## Town of Kittery Planning Board Meeting July 13, 2023

#### ITEM 4 – 21 Badgers Island West–Shoreland Development Plan Review

#### APPLICATION & PLAN REVIEW

- 6. THE AVERAGE GRADE OF THE EXISTING GROUND AT THE BUILDING IS 19.3,

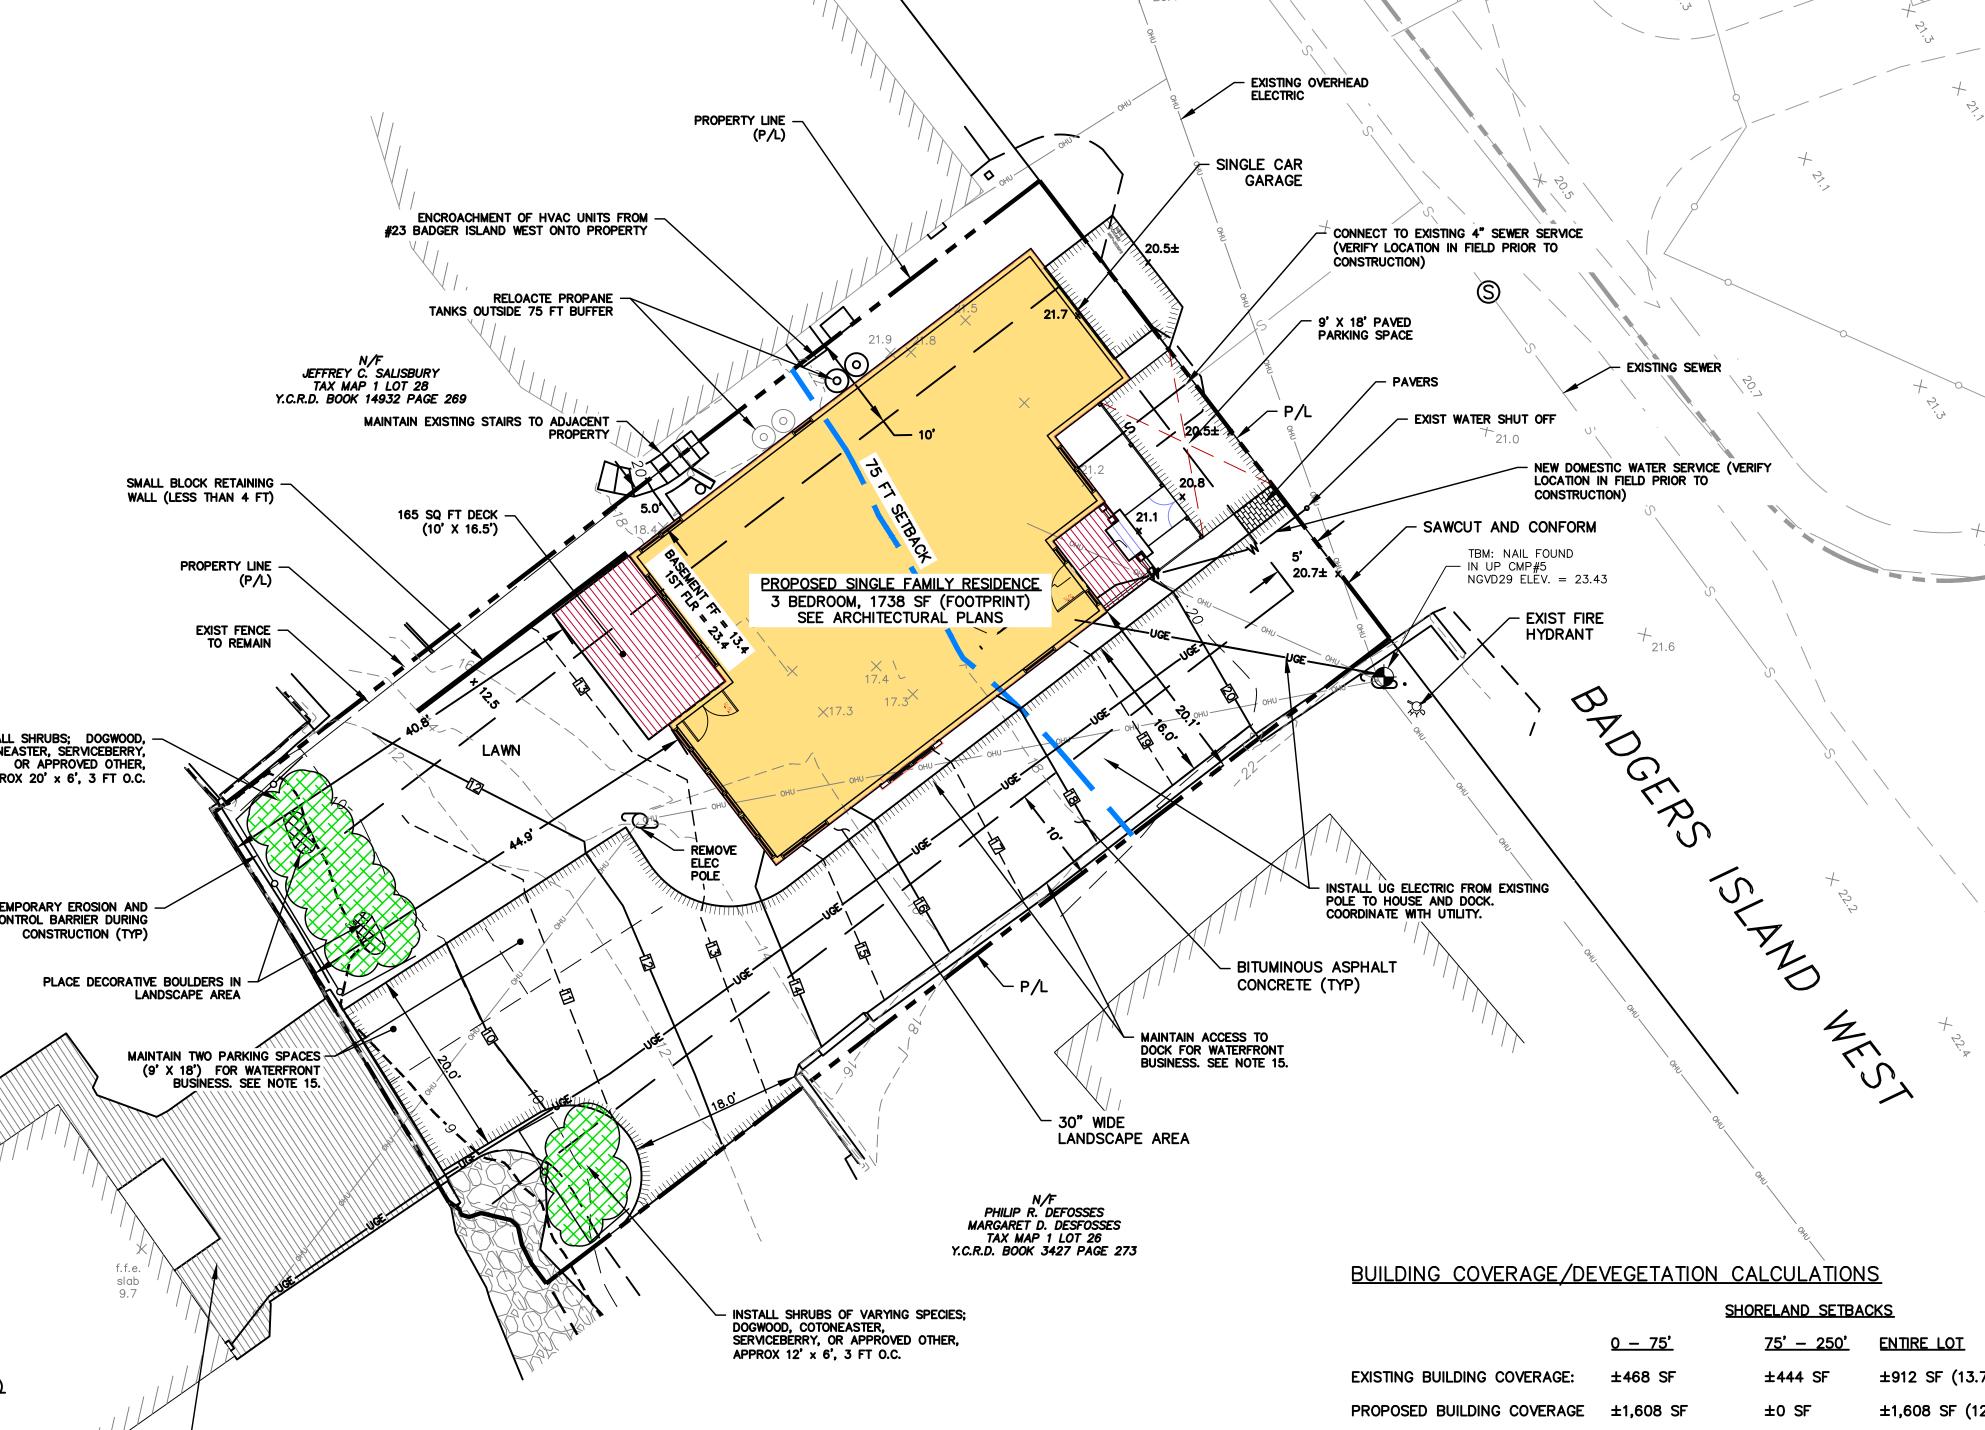
- 3. **§16.4.28.E.(2).(a).** allows 60% of total lot area in the Mixed-Use Badgers Island zone's shoreland overlay to be comprised of non-vegetated surfaces or structures. With a lot size of 6,648 sq ft, current devegetation sits at 4,814 sq ft, or 72.4%. The proposed development would reduce non-conformity by lowering the total devegetated area to 4,668 sq ft, or 70.2%.

- a. The notes on the site plan's devegtetation calculation only add up to 4,646 sq ft, do to an accidental omission of a granite stairway totalling 22 sq ft. The applicant confirmed 4,668 sq ft. is the correct number.

SILT AND ORANGE CONSTRUCTION FENCE LAYOUT DETAIL

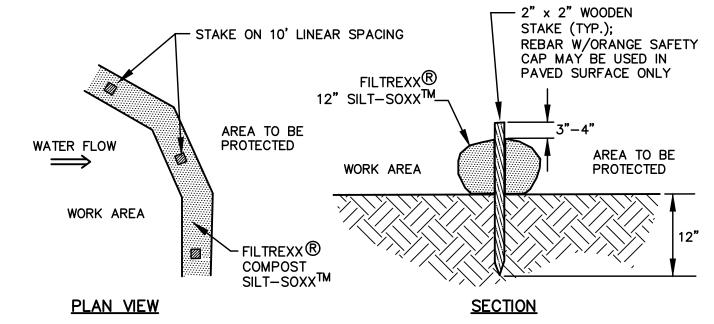
- 4. Erosion control measures shall comply with state DEP and local ordinances. The applicant provided a detailed layout of the silt barrier and orange construction fence that will be placed before construction and maintained throughout the development to protect the resource from erosion or sediment runoff. Disturbed areas will be stabilized with loam and seed plantings before removal of temporary erosion control barriers.
